TO:  Marco Foster, MS47354  
THRU:  T. Madden / K. Klingman, NB82-230  
FROM:  P. Fuller / S. Beadle, NB 82-66  
SUBJECT: C8549  
SR99, AWV Replacement North Access Connection  
F.A. Project No: STPF-0099(122)  
**CHANGE ORDER 133**  
**Ductbank Changes EN1, EN3, EN4 & EP5**

**WASHINGTON STATE  
DEPARTMENT OF TRANSPORTATION  
CHANGE ORDER**

CONTRACT NO: 008549 FEDERAL AID NO: STPF-0099(122)  
 CONTRACT TITLE: SR 99, ALASKAN WAY VIADUCT - REPLACEMENT NORTH ACC  
 CHANGE ORDER NO: 133 R1 EN1, EN3, EN4, EP5 DUCTRANK CHGS.

PLAN REF. NO.	UPD11
SHEET	241
OF	770
SHEETS

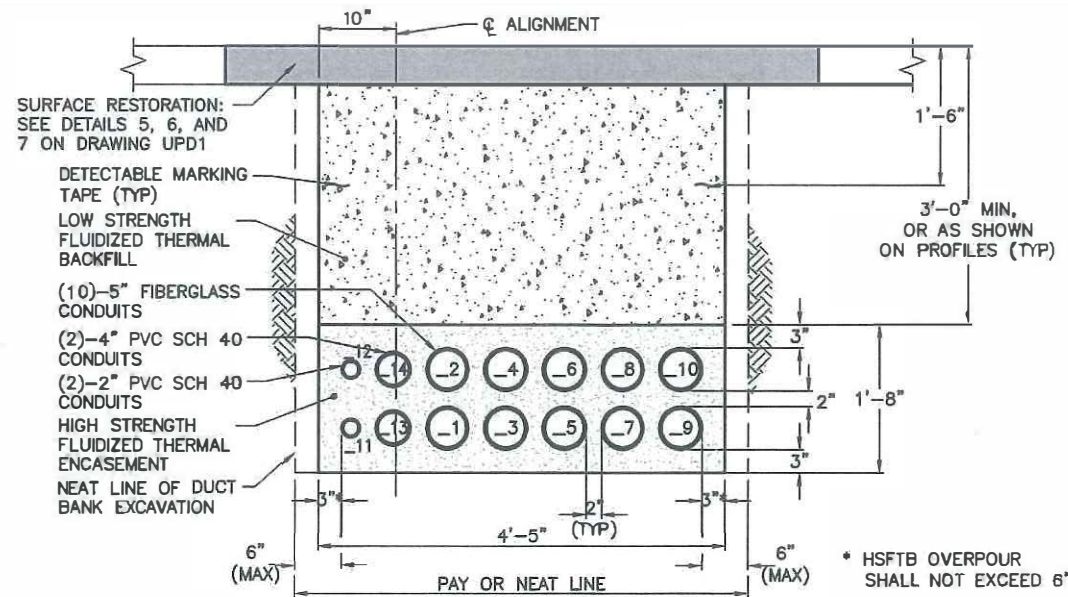
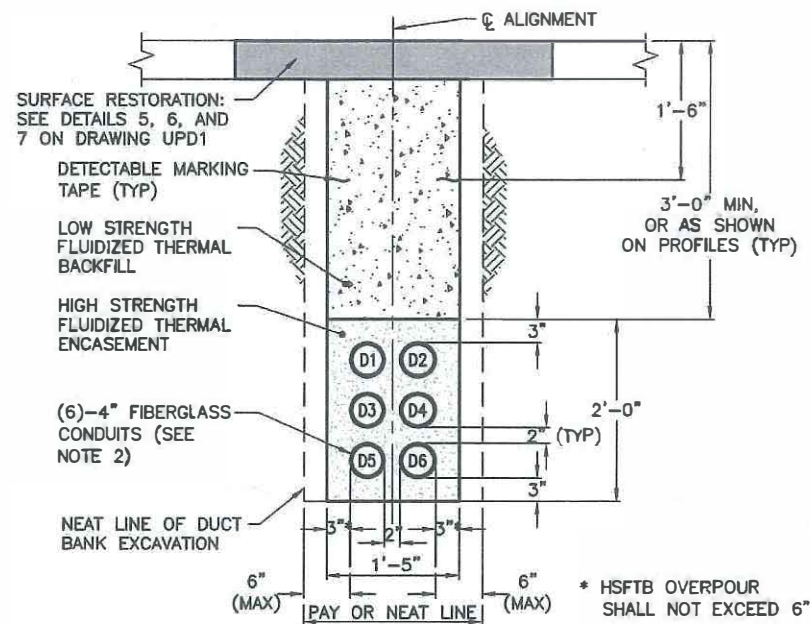
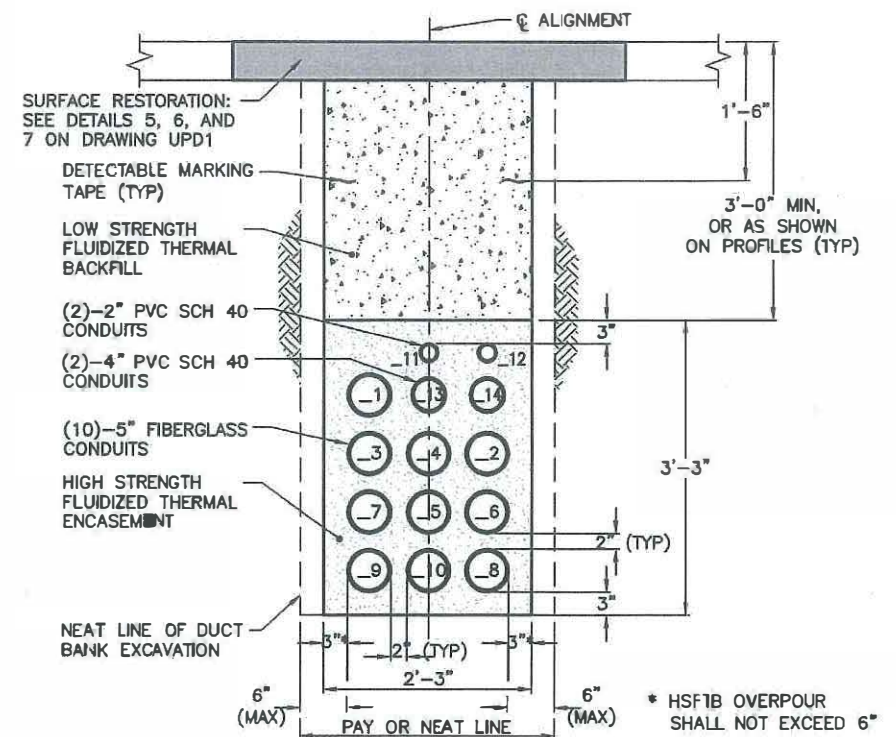
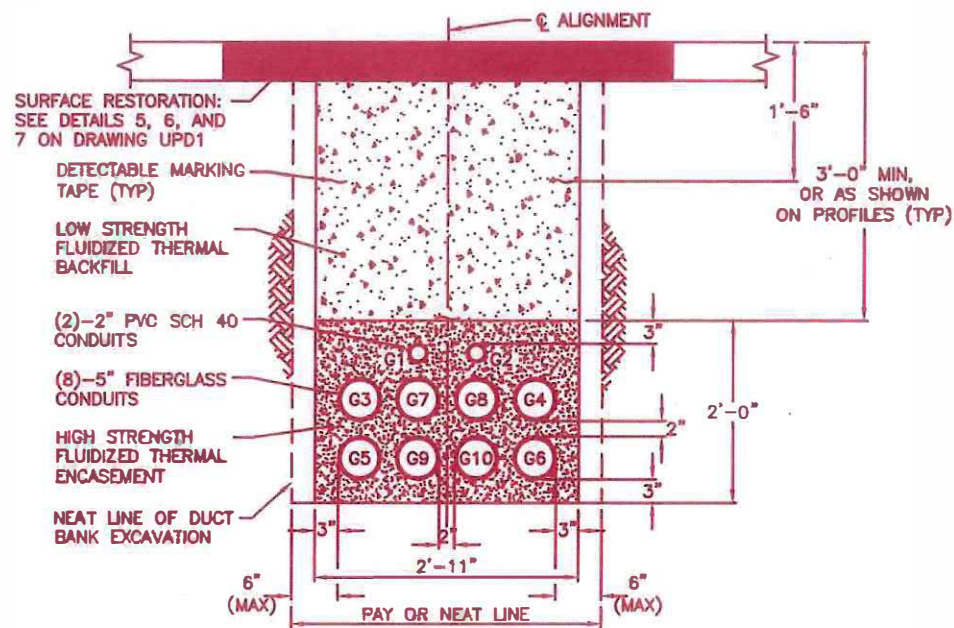
Revises the horizontal and vertical alignments of ductbank EN3 as shown on UPAL1, UP1, UP8, UPR8, UPR9, UPD11 and UPD33.

DUCT BANK DOWEL DETAIL **20A**  
 SCALE: 1"=1'  
**UPD20**

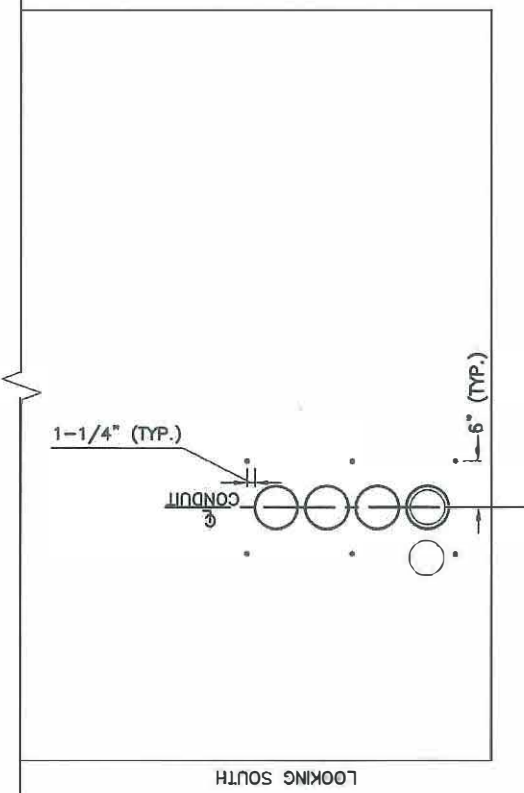
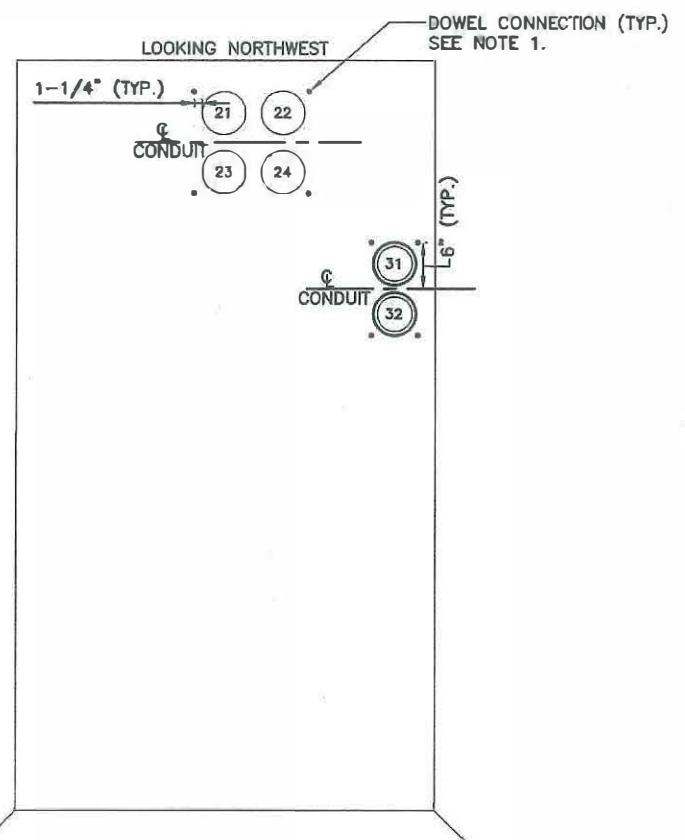
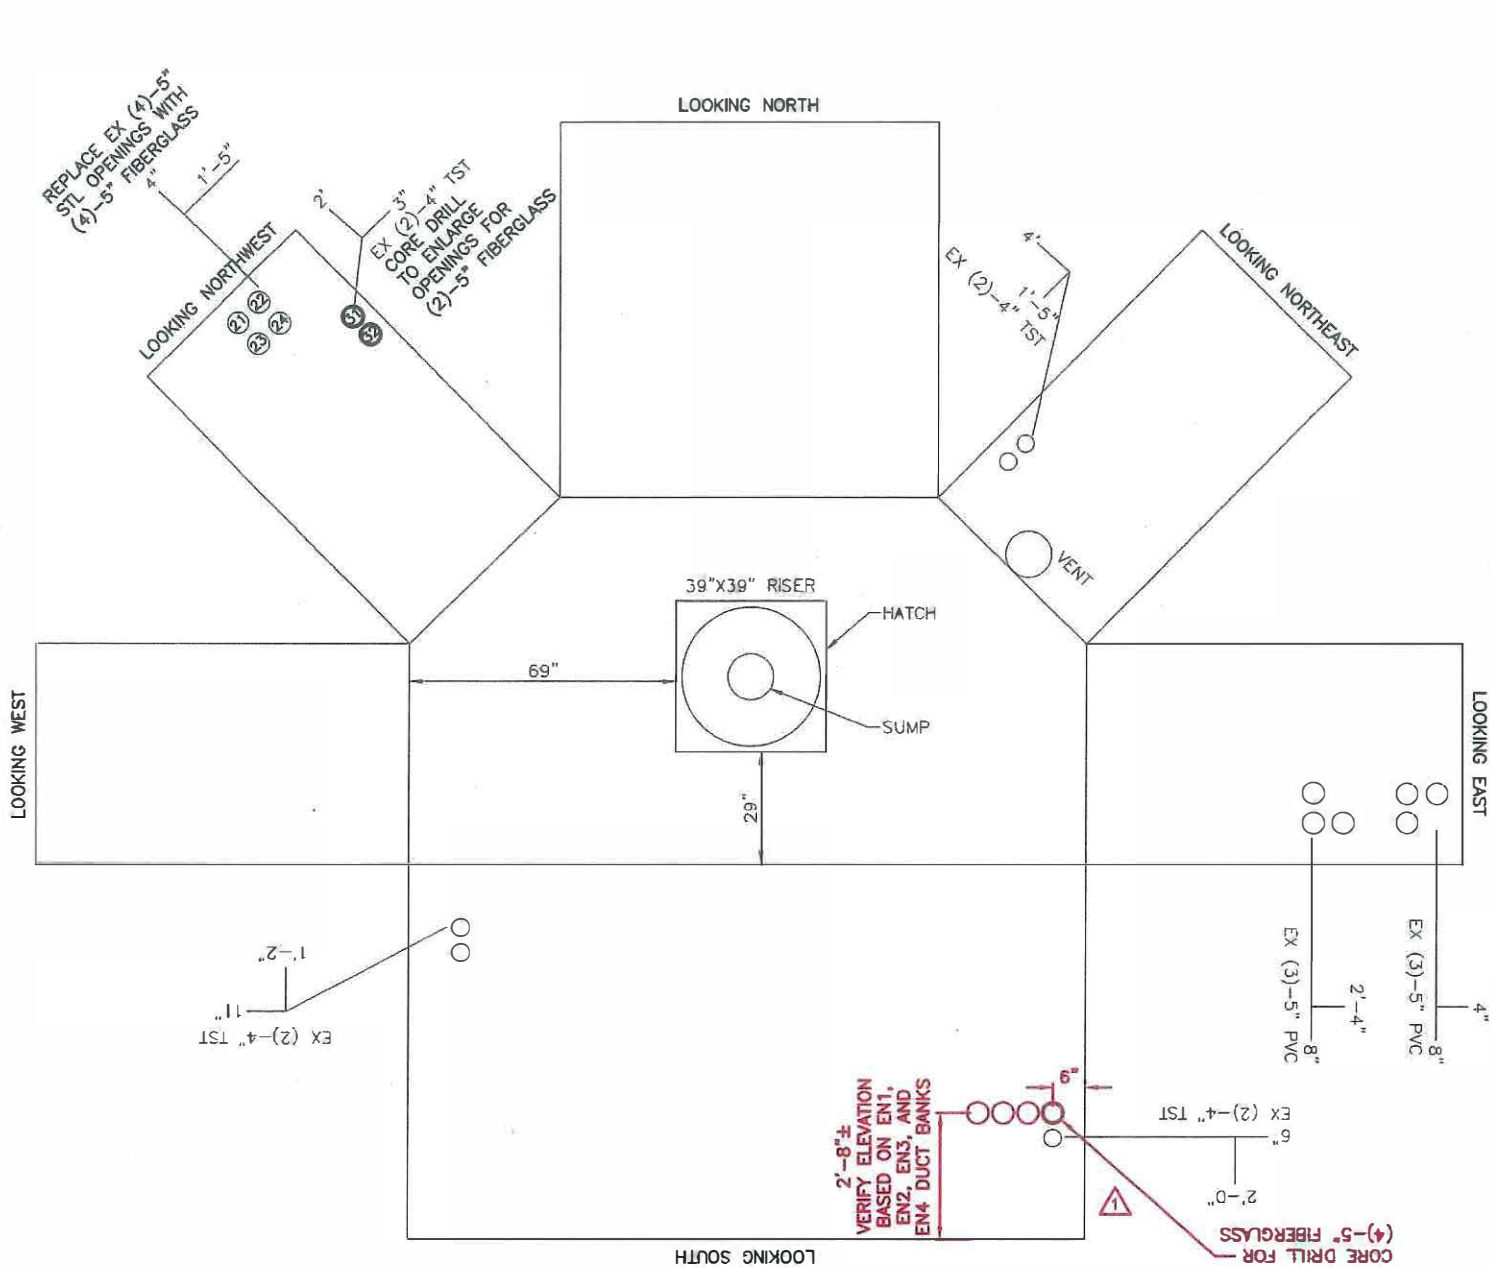
Adds new ductbank EP5 feeders from Station EP5 350+00.00 to 350+10.86 to the SCL Substation yard as shown on UPAL1, UP1, UPR7-UPR9, UPR10, UPD20, UPD33. New ductbank EP5 shall be positioned in between ductbanks EN1 and EN3 above and ductbanks EN4 and EN2 below.

**NOTES**  
 1. DOWEL NEW DUCT BANK INTO EXISTING VAULT WALL TO PROVIDE SHEAR CONNECTION. DOWEL #4x16 STEEL REBAR INTO THE VAULT WALL WITH EPOXY (4\"/>

PLAN REF. NO.	UPD33
SHEET	263
OF	770
SHEETS

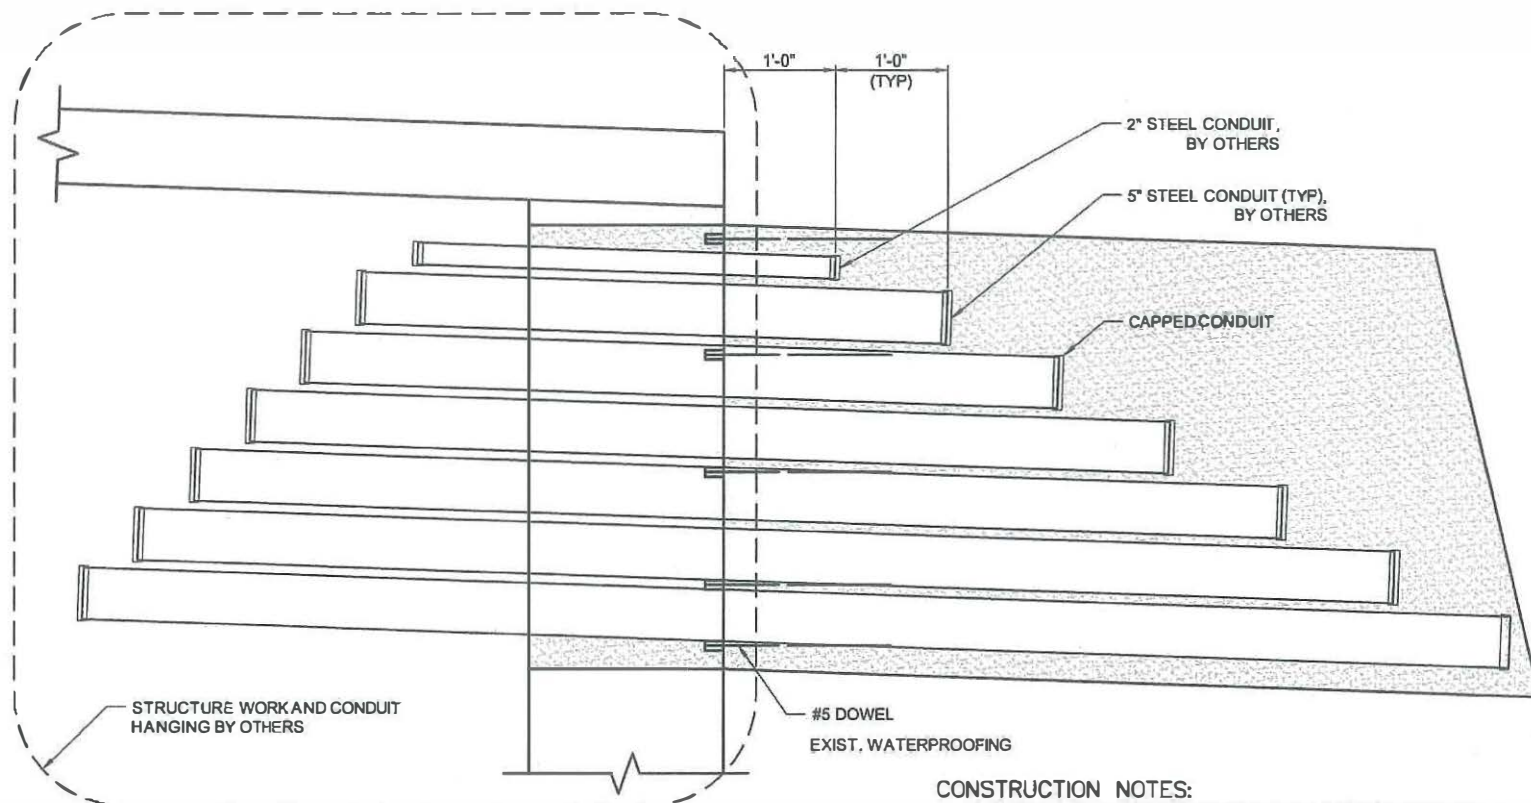
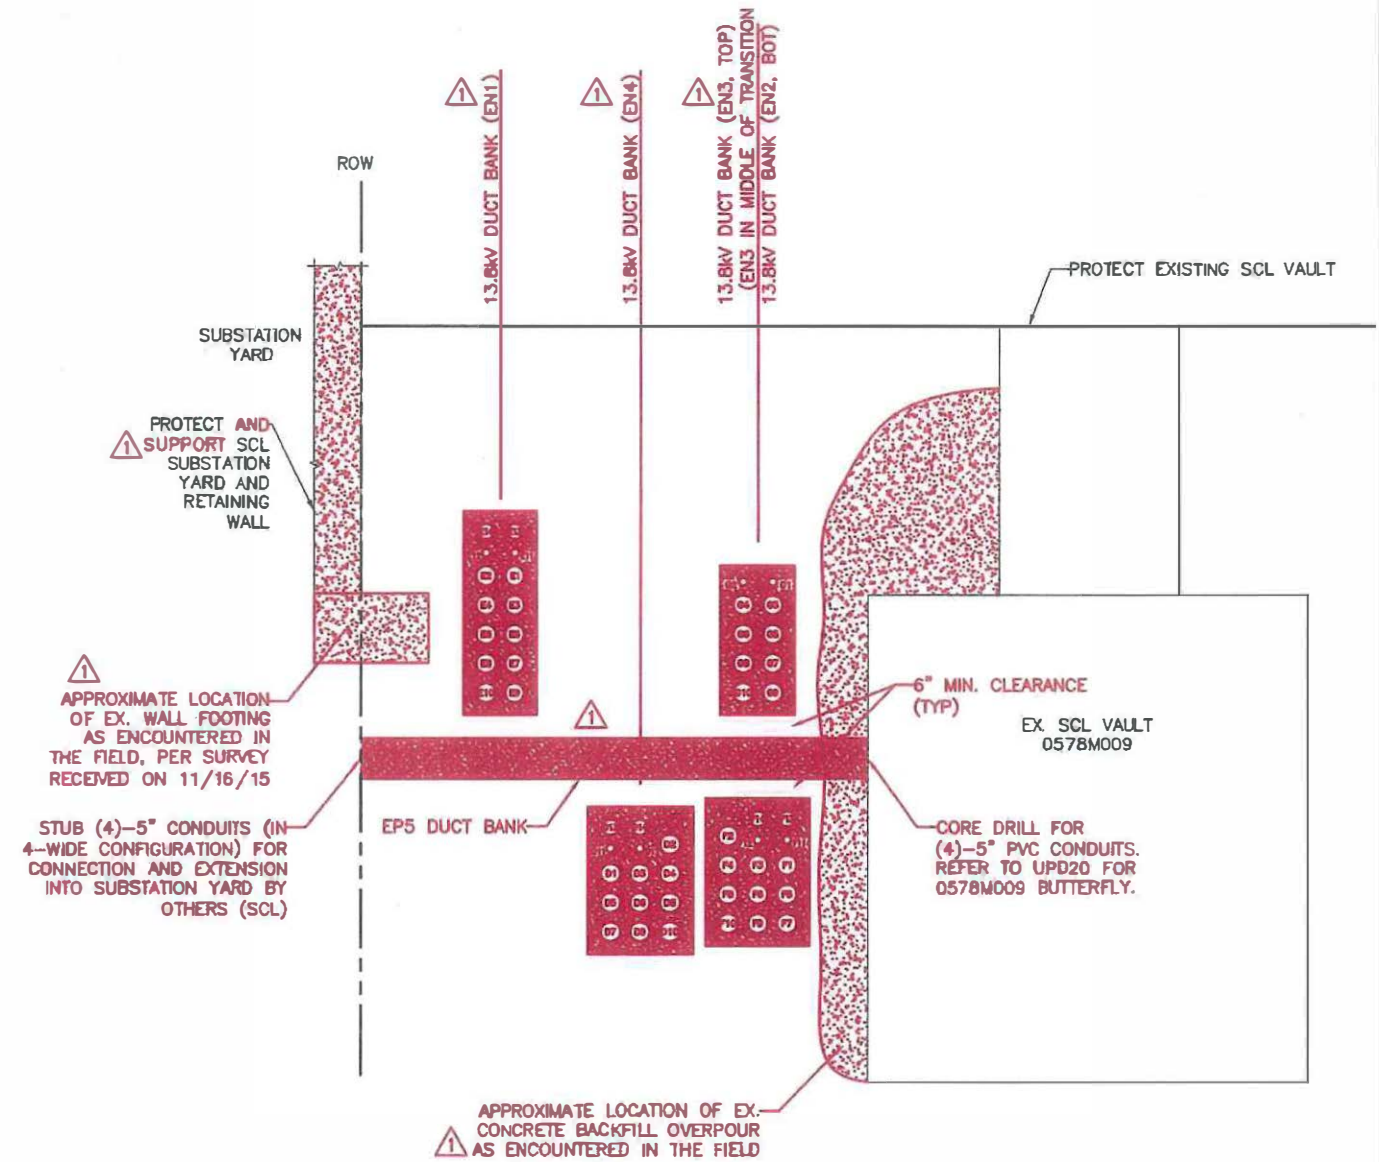
Revises the horizontal and vertical alignment of ductbank EN1 as shown on UPAL1, UP1 and UPR7. Raises EN1 vertical alignment to be above new ductbank EP5 and above EN2 and EN4 as shown on UPD33 and UPD33A. Revises horizontal alignment to run along the Substation Yard retaining wall foundation. This change order compensates the Contractor for the added effort and complexity for working along the SCL Substation retaining wall as shown on UPD33 and UPD33A.

1. THIS DETAIL REFLECTS THE CONDUIT TERMINATION CONDITION DEPICTED WITHIN THE SR99 TUNNEL PROJECT DESIGN. THE CONTRACTOR SHALL CONNECT TO THE CAPPED CONDUITS IN THE LOCATIONS NOTED ON THE PLANS.
2. SAND BACKFILL SHALL BE REMOVED VIA VACTOR TRUCK. CARE SHALL BE TAKEN TO AVOID DAMAGING THE EXISTING CONDUITS AND WATERPROOFING.
3. DUCT BANK ENCASMENT SHALL ENCOMPASS EXISTING DOWEL BARS TO CONNECT DUCT BANK TO TUNNEL STRUCTURE.
4. WHERE DUCT BANK HAS LESS THAN 3' COVER, A STEEL PLATE SHALL BE INSTALLED IMMEDIATELY ABOVE THE HSFTB ENCASMENT.
